ASBESTOS ABATEMENT

ADDENDUM NUMBER ONE

May 10, 2024

LAKE COUNTY COURTHOUSE

FIGURE 1

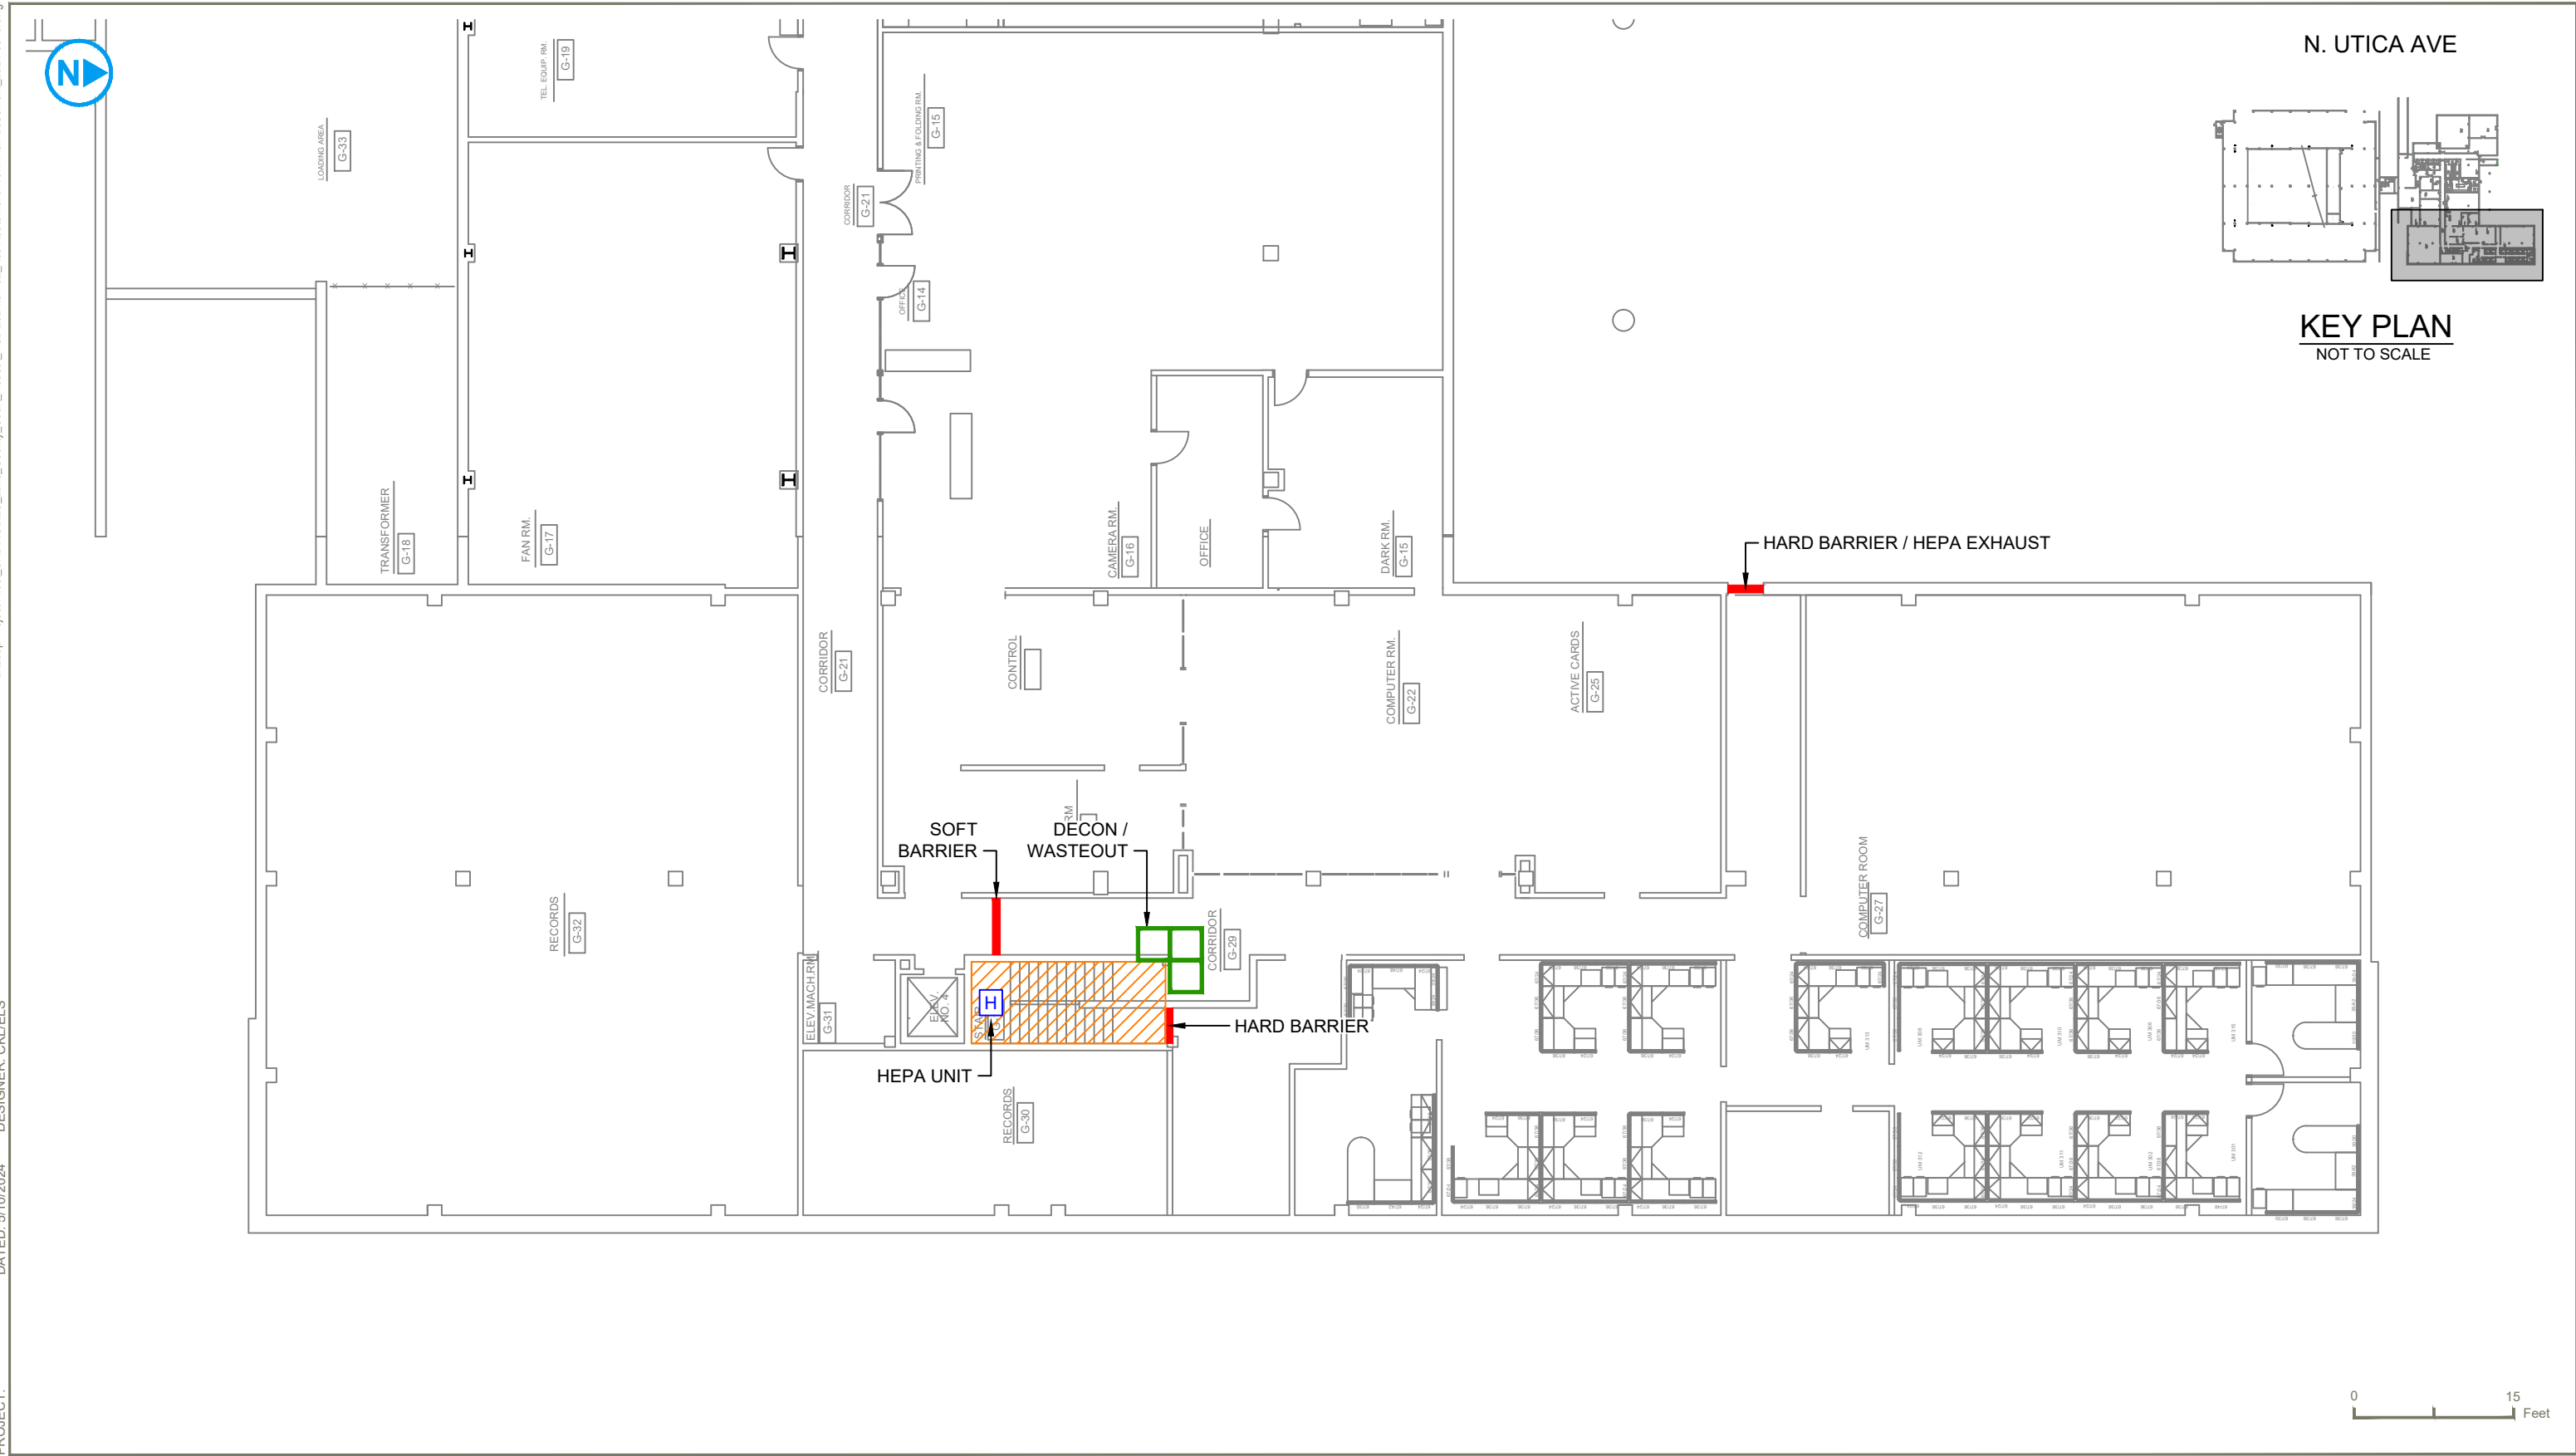
2. If it is determined that the G27 Stairwell has firewalls to the ceiling deck, then the ceiling can be removed with the asbestos skim coat intact.
3. Glovebag abatement in the Storage Room has been removed from the scope. The schedule and abatement drawings has been revised accordingly.

4. Barrier locations on the abatement drawings have been revised.
5. Any asbestos floor tiles that are covered by the tunnel in the Mainframe room should be removed using heat removal methods following teardown (approximately 12 tiles).
